Three Mile Island Nuclear Station, Unit 2 (TMI-2)  
Operating License No. DPR-73  
Docket No. 50-320  
Canister Handling and Preparation for Shipment  
Safety Evaluation Report, Revision 4

Attached for your review and approval is Revision 4 to the Safety Evaluation Report (SER) for Canister Handling and Preparation for Shipment (CHAPS). The following sections have been revised:

SAFETY EVALUATION REPORT

CANISTER HANDLING AND PREPARATION

FIGURE 2-1

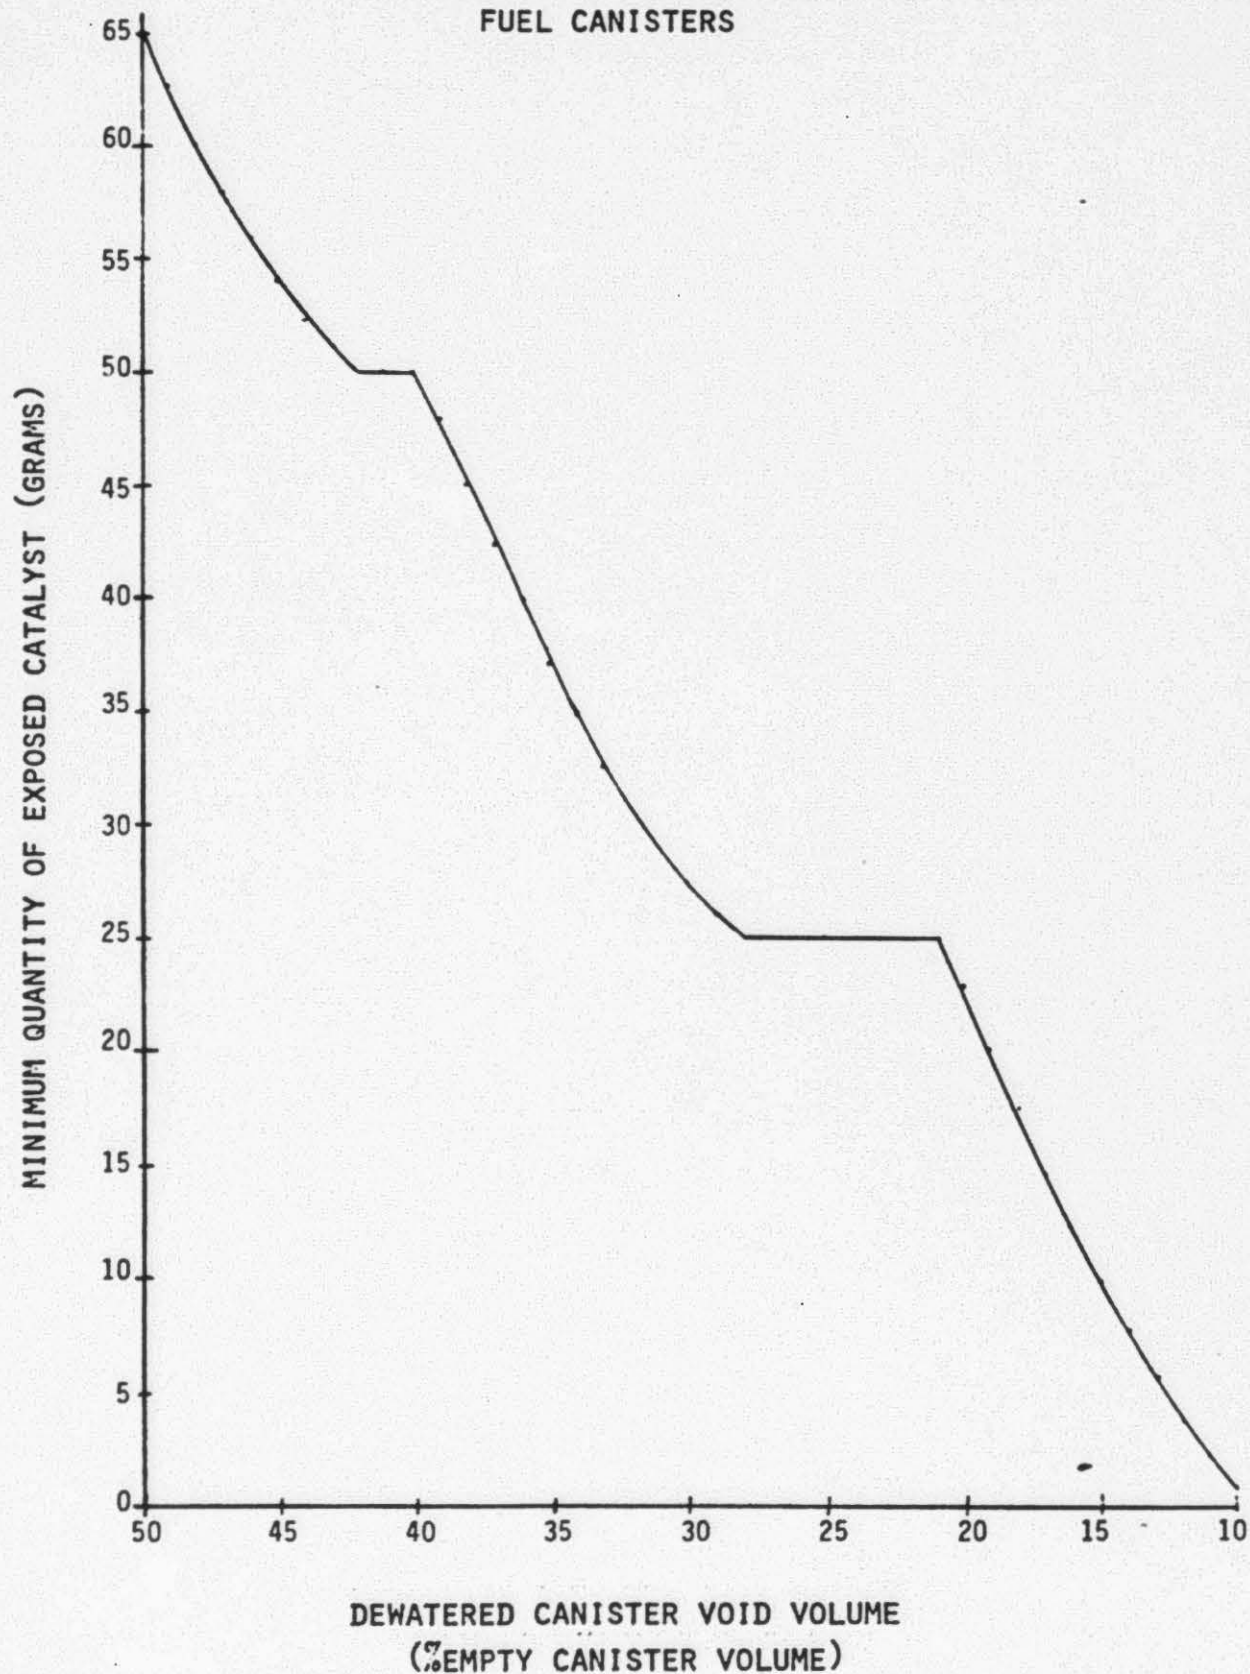
Figures 2-1 and 2-2 graphically show the minimum quantity of exposed catalyst for any canister orientation as a function of dewatered canister void volume. Compliance to the canister dewatering acceptance criterion is achieved when the minimum quantity of exposed catalyst, for the calculated dewatered canister void volume, exceeds the sufficient quantity of catalyst defined above.

The required minimum recombination rate is equal to the expected radiolytic gas generation rate in the canister and the allowable maximum oxygen concentration is equal to five volume percent. For conservatism, the expected radiolytic gas generation rate is assumed to be the "probable-maximum" generation rate of 0.11 liter per hour (per 100 watts of decay heat) calculated in Reference 17, and referred to as the "maximum theoretical" rate in Reference 15. Since the gas generation rate is proportional to the decay head load (W) in the canister, the safety factor is inversely proportional to W. Therefore, the safety factor on 100 grams of catalyst in a canister with decay head load of W watts is  $(100/W) \times SF$ . The required quantity of exposed catalyst is  $(100 \text{ grams}) / ((100/W) \times SF)$  or  $W/SF$  grams. Hence, a sufficient quantity of exposed catalyst is  $1.5 \times W/SF$  grams.
